To: Greater Cambridge Partnership
Authors: Edward Leigh, Jim Chisholm, Sam Davies, Chris Rand et al
Date: 11 April 2018
Subject: Response to Cambridge South East Transport Study consultation 2017/18
Contact: 01223 312 377 / edward@smartertransport.uk / [@SmarterCam](https://twitter.com/SmarterCam)

Smarter Cambridge transport supports most of the short-term measures proposed (some with modifications), but believes that these alone are inadequate to address the urgent transport needs of the Biomedical Campus, with Papworth Hospital, Abcam and AstraZeneca opening their doors over the coming year. If Greater Cambridge Partnership does not act quickly and decisively to increase public transport capacity and attractiveness, two more car parks (already granted outline planning consent) will inevitably be built on the Biomedical Campus, with potentially disastrous consequences for the local road network and ambulance response times.

Appendix 1: Map of proposed interventions

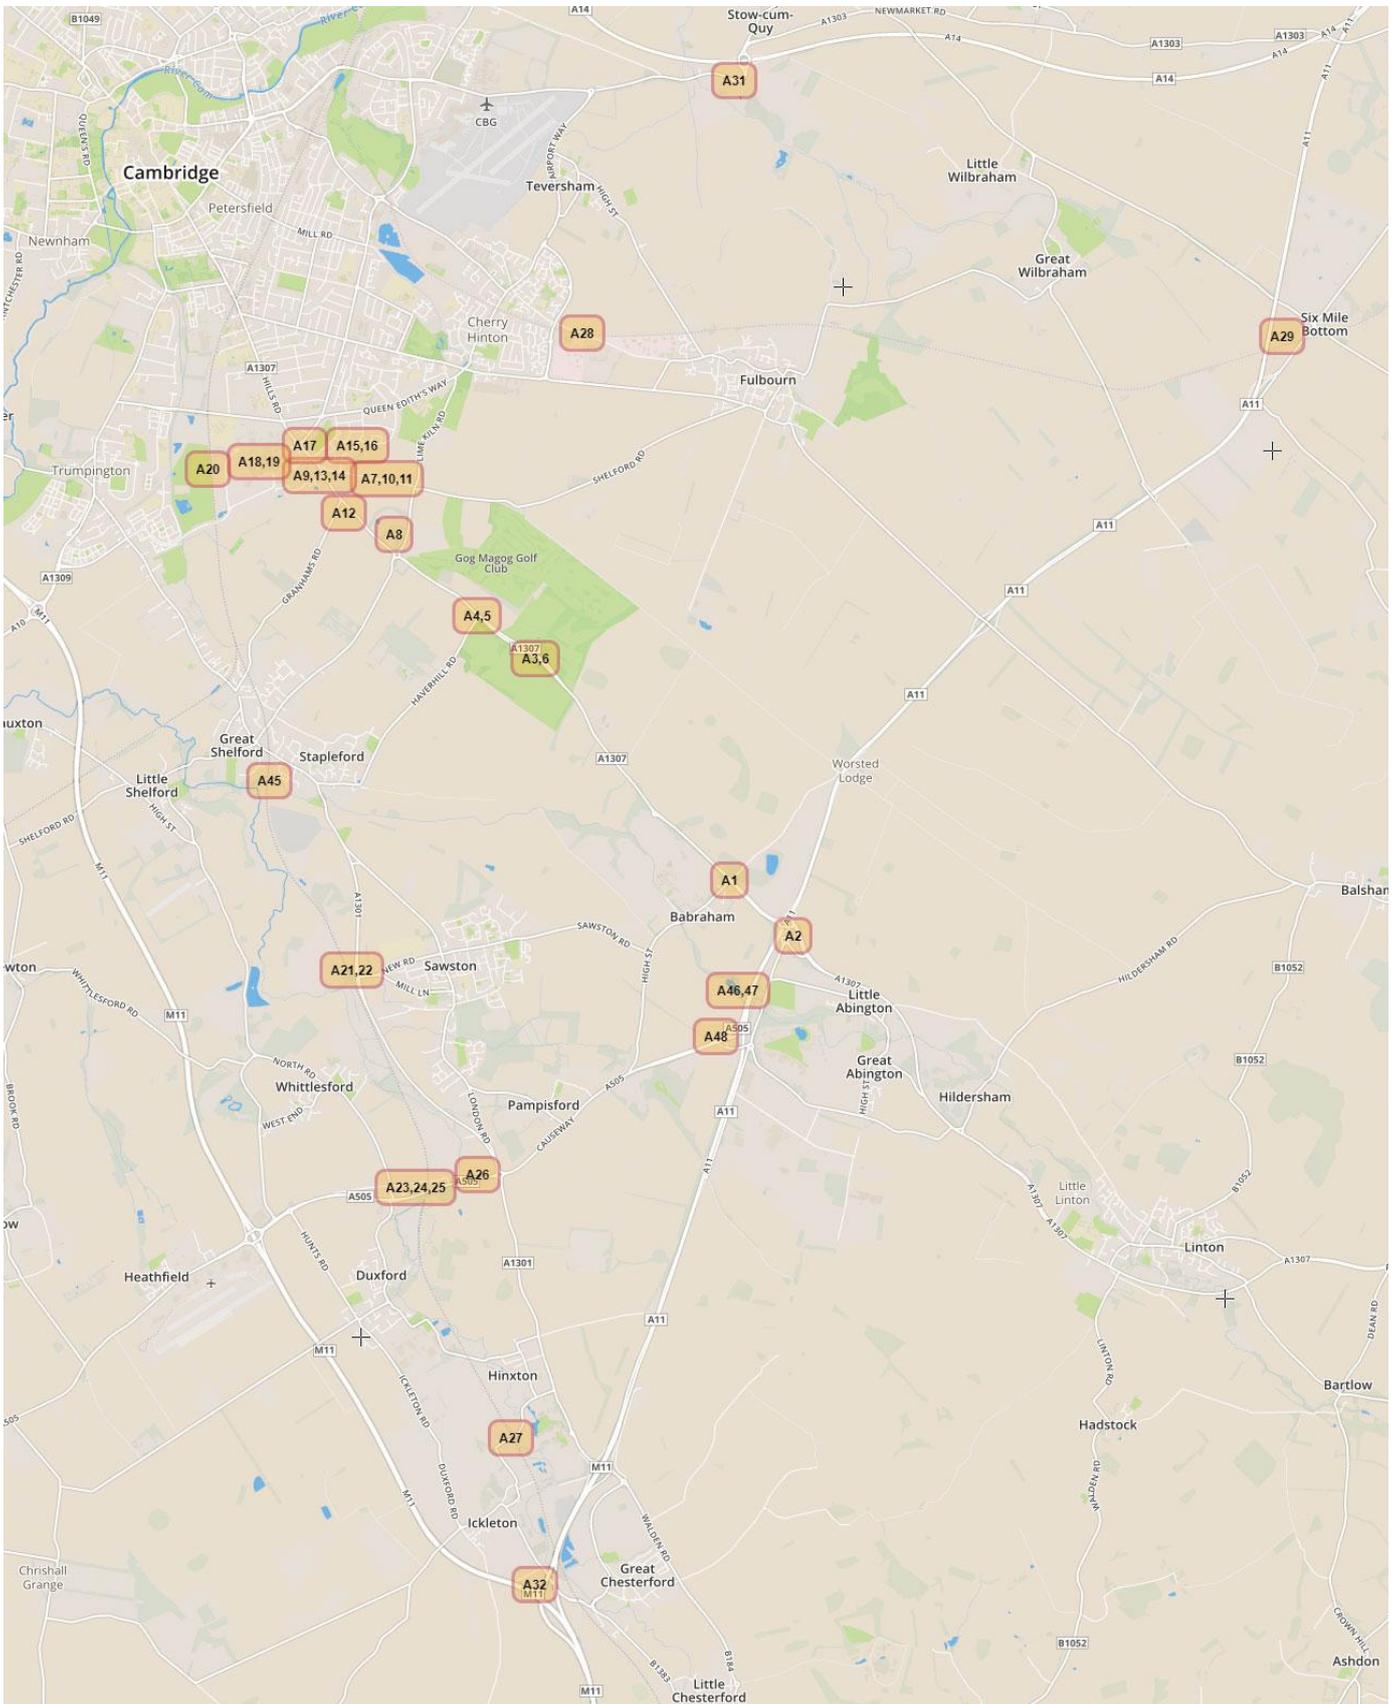
We see Strategy 3 as a viable short-to-medium term measure if road widening is avoided as far as possible, and alternative measures are introduced to increase bus priority and safety for all road users. We call this ‘Strategy 3a’. Interventions are shown on a map in Appendix 1.

Figure 1: Collisions recorded at the Babraham High St junction with the A1307 (© Cyclestreets and OpenStreetMap)

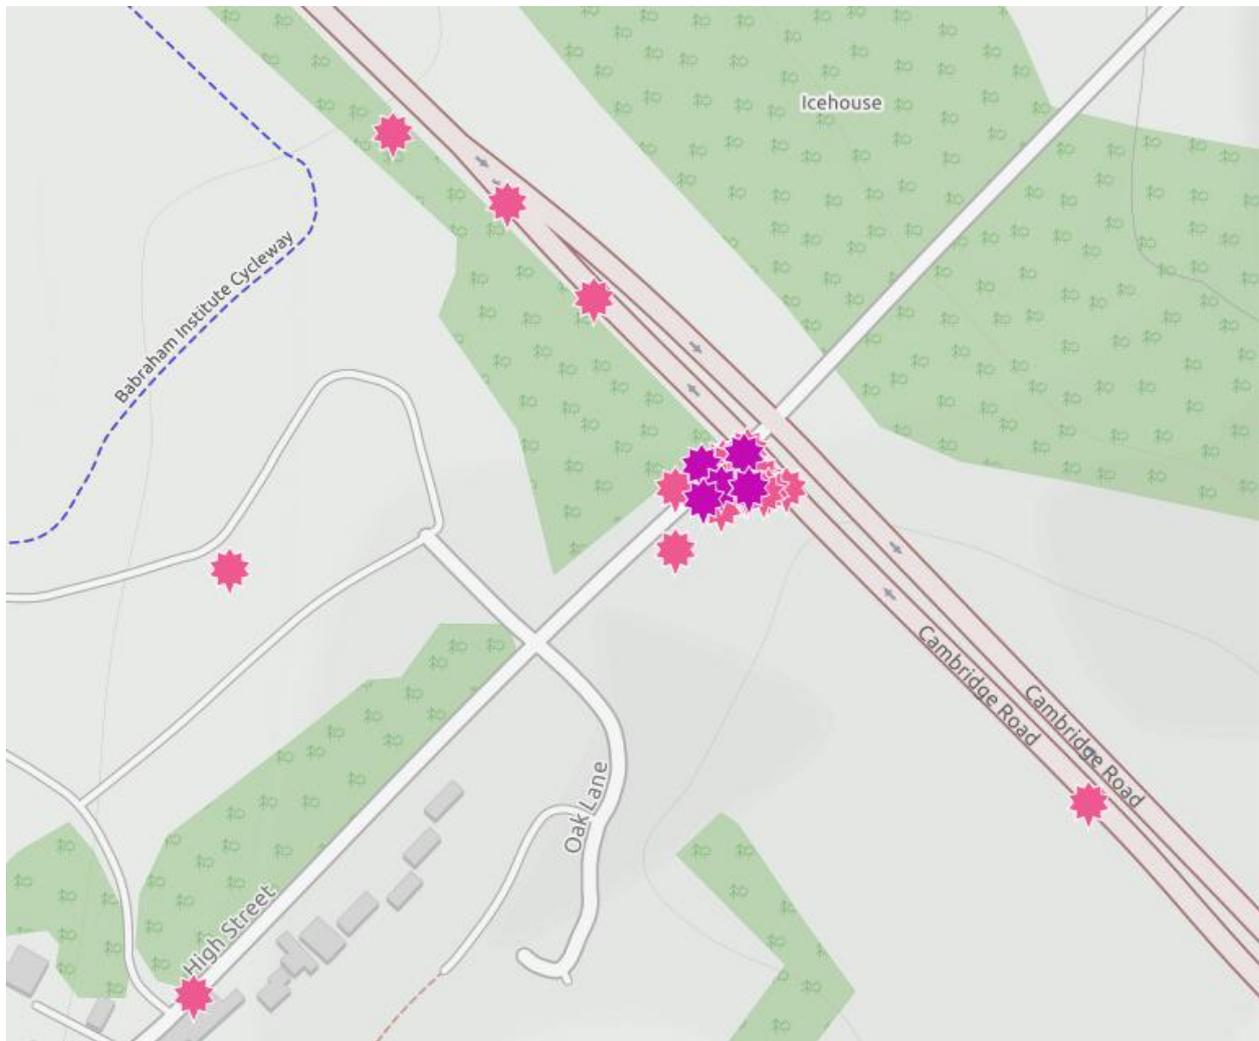
- S6. *Babraham Research Campus roundabout:* We **support** the addition of a new signalised crossing here.
- S7. *Eastbound bus lane at A11:* We **support** the reallocation of a filter lane to a bus lane and, subject to further detail, safety improvements at the Babraham High St junction.

Figure 4: Potential cycle/footway link to divert some cycle traffic off the Hills Rd footway

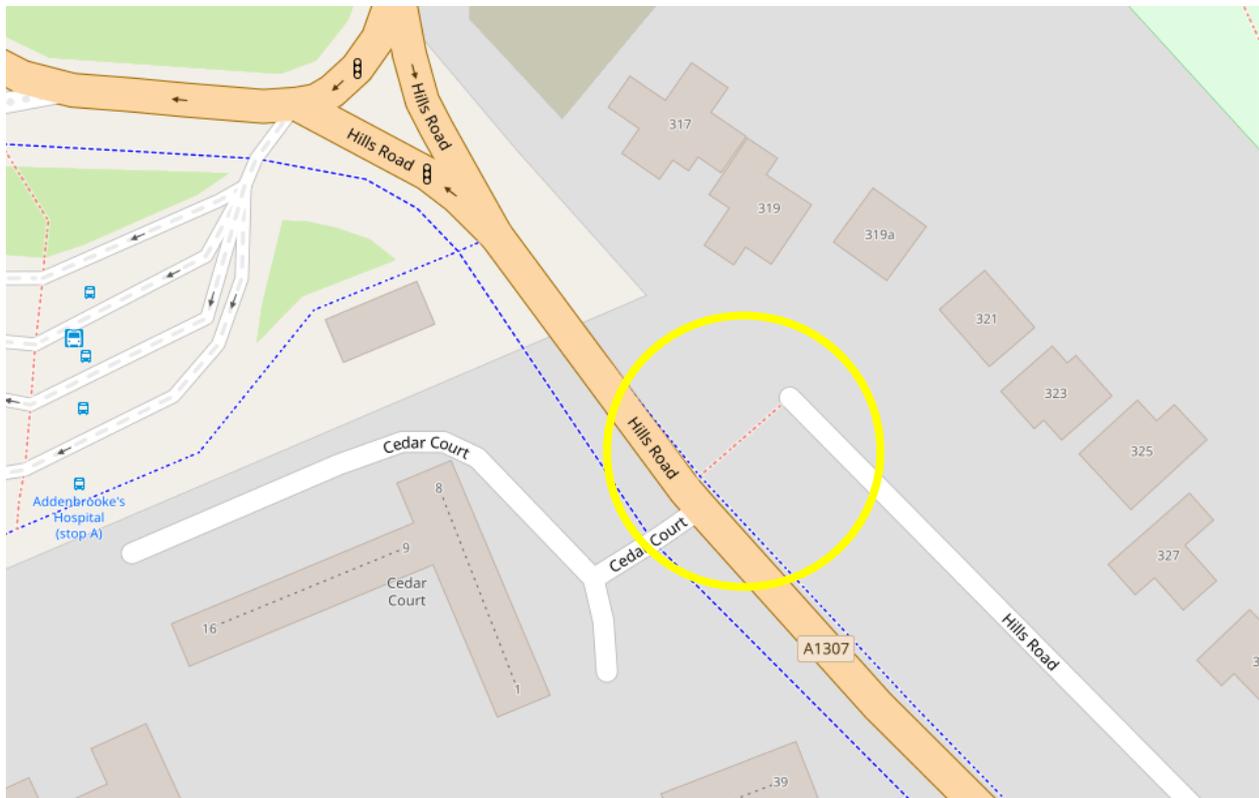
- A17. Open up the pathway connecting Hills Rd with the parallel residential access road (see Figure 4 & Figure 5). This would enable cycle traffic to be diverted off the Hills Rd footways, reducing conflict between cycles and pedestrians.

Figure 7: Peak-time bus route, bypassing queues on Babraham Rd

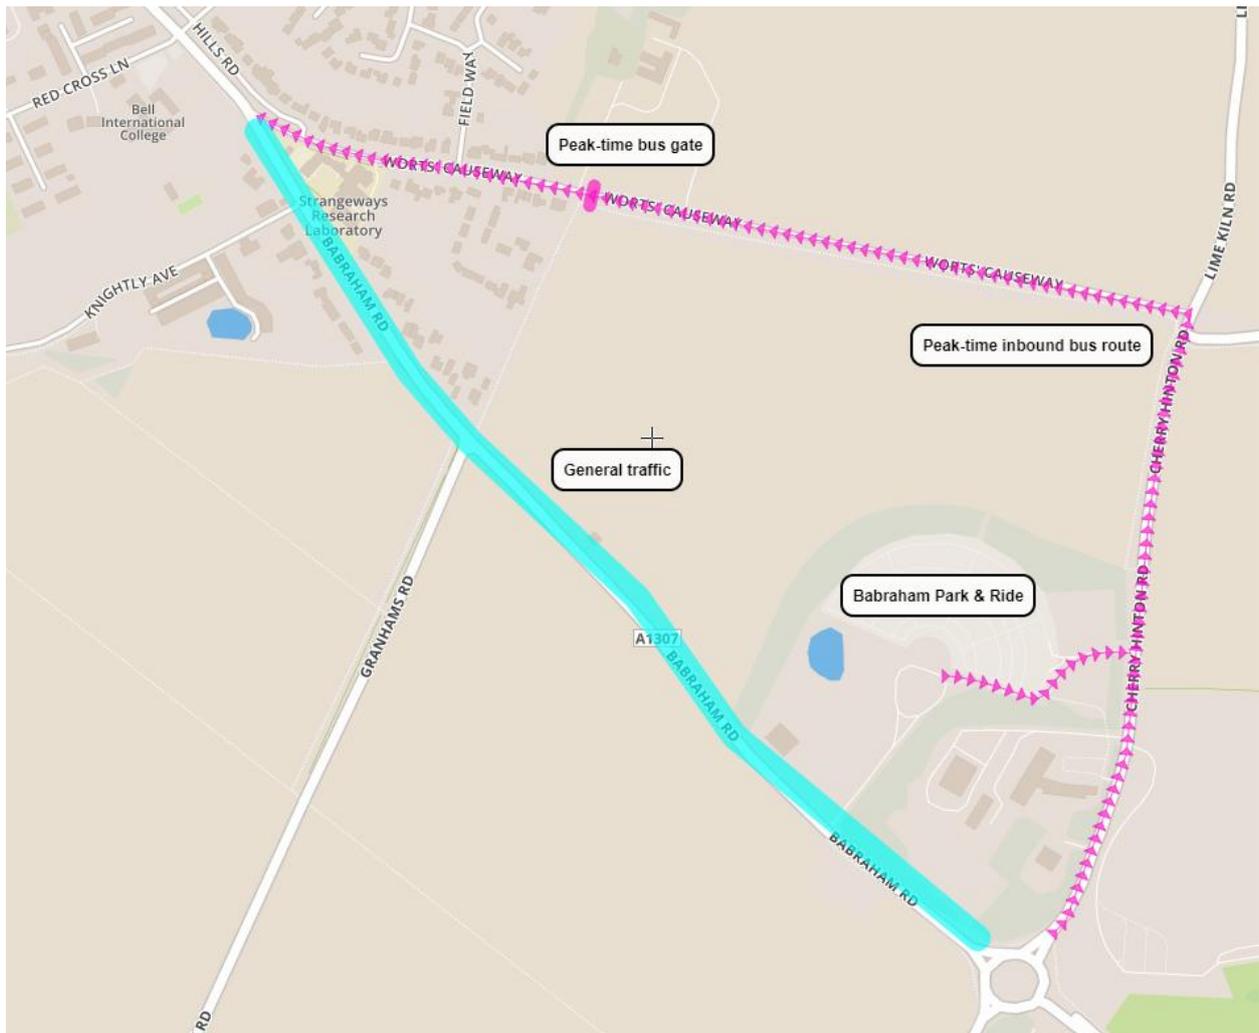
- A7. Update the existing access restriction on Worts' Causeway to act as a bus gate during peak hours (see Figure 7). At these times, the only vehicles using Worts' Causeway east of the bus gate (where there are no houses) would be buses travelling towards the city. This would include services from Babraham P&R and Haverhill (service 13). Consult with local residents about extending the hours of restricted access to deter rat-running.

- A8. Within Babraham P&R, add an outbound bus lane from the bus station alongside the car park entry lane to enable buses to exit directly onto Cherry Hinton Rd at peak times. This would give buses access to Cambridge via Worts' Causeway, avoiding congestion on Babraham Rd. The detour would be just 430m (about 45 seconds).

Figure 8: Possible location for a bus turnaround for Whittlesford Parkway station

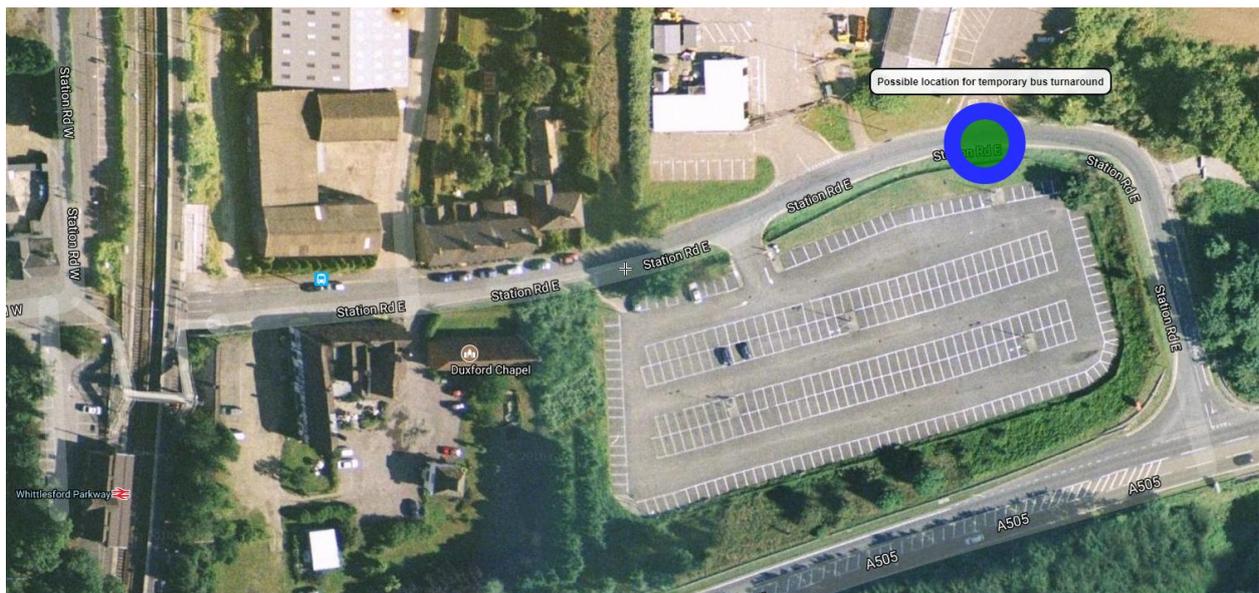
- A42. Discuss with Granta Park and IWM Duxford subsidising a shuttle service along the A505 between the two locations, calling at Whittlesford Parkway station (with a bus turning circle – see Figure 8). A single bus could provide a 20–30 minute frequency service.

Figure 9: Possible new routes for 7 and 7X (express) bus services

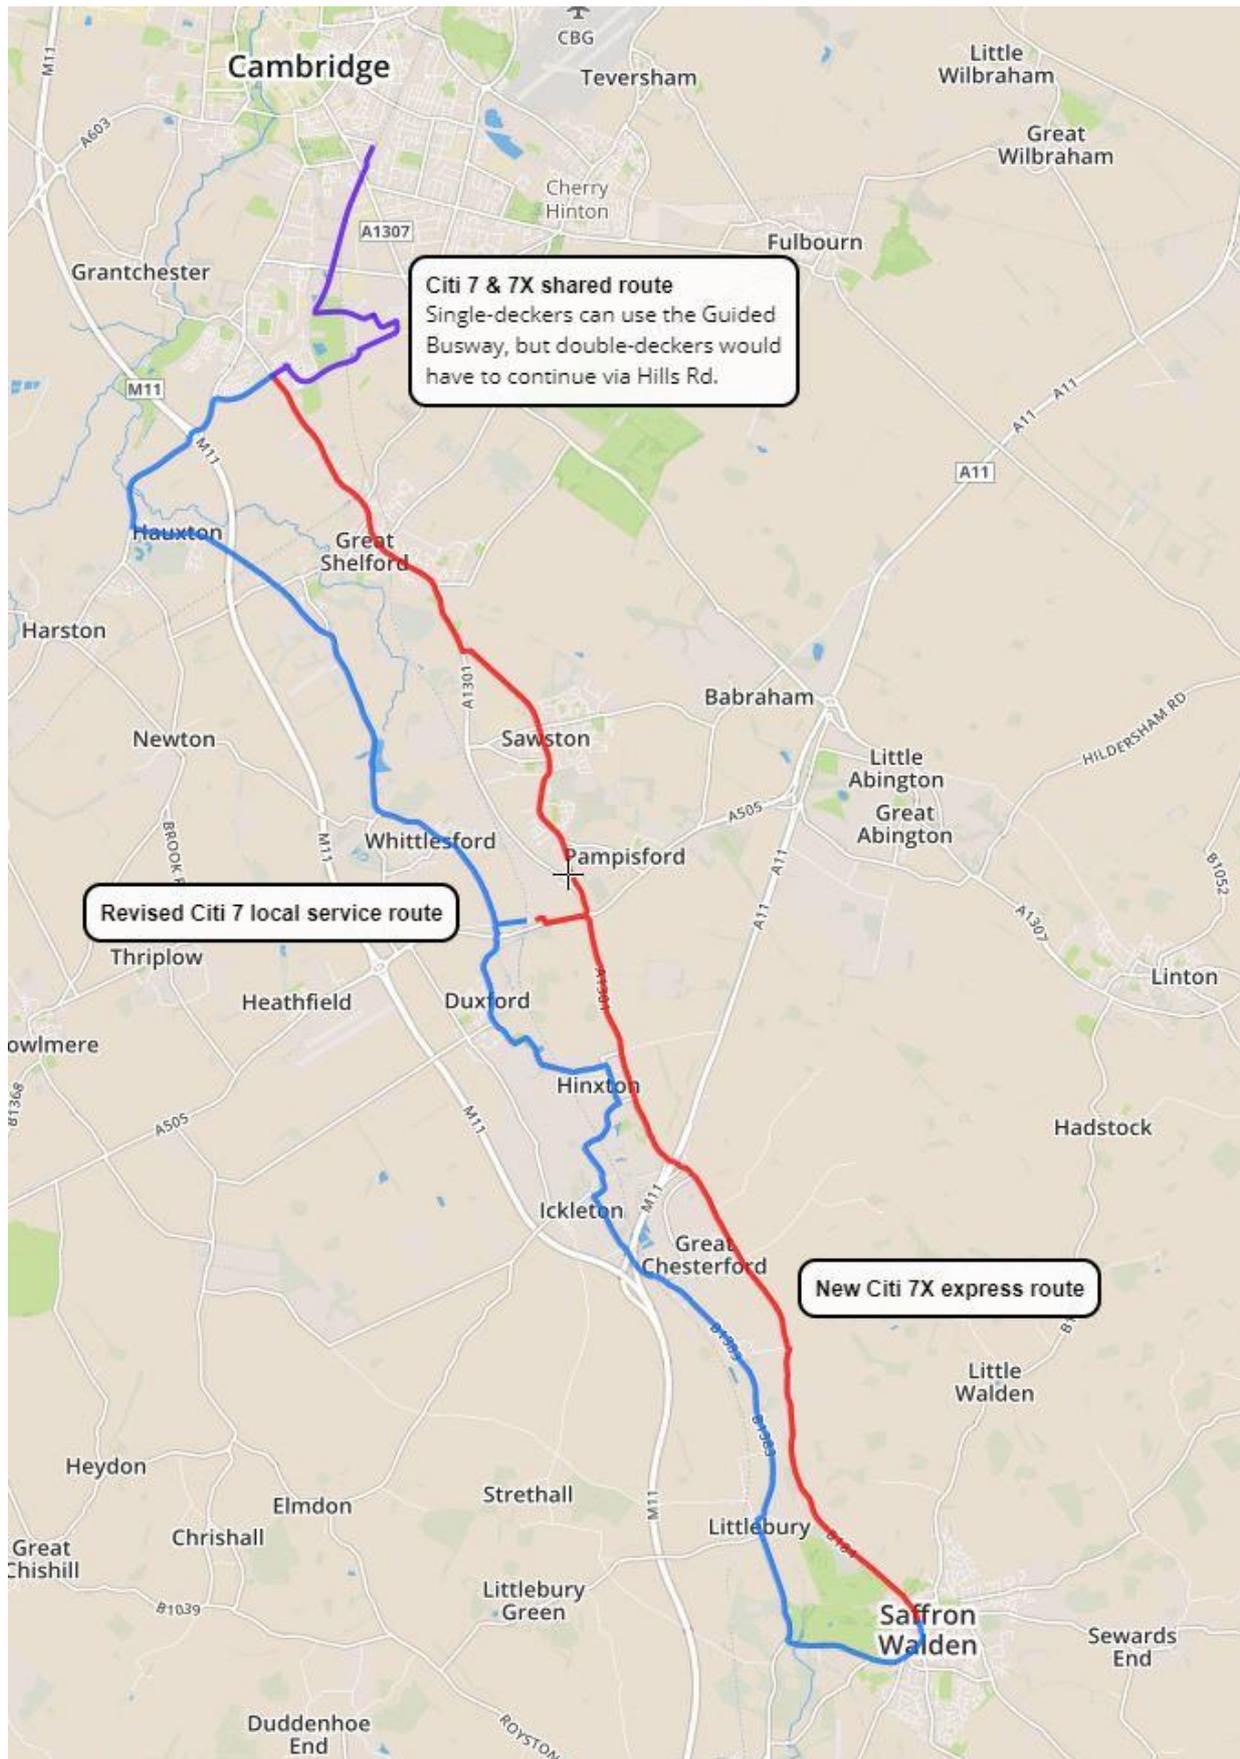
- A36. Split the Citi 7 service into two services from Saffron Walden: Citi 7X ('express' via the B184 and A1307) and 7 ('local' via villages between the M11 and B184/A1301) – see Figure 9 for a map of these:

- **Citi 7X:** hourly (half-hourly at peak times) from Saffron Walden via Great Chesterford, Wellcome Genome Campus (stop on roundabout), Hinxton*, Whittlesford Parkway, Sawston, Stapleford, Great Shelford, Biomedical Campus, Cambridge station, Cambridge city centre.

- **Citi 7:** hourly from Saffron Walden via Audley End Estate, Littlebury, Great Chesterford station, Ickleton, Hinxton, Duxford, IWM Duxford, Whittlesford Parkway (as close as possible to the station, ideally using a turnaround on Station Rd West), Whittlesford, Little Shelford, Great Shelford, Biomedical Campus, Cambridge station, Cambridge city centre.
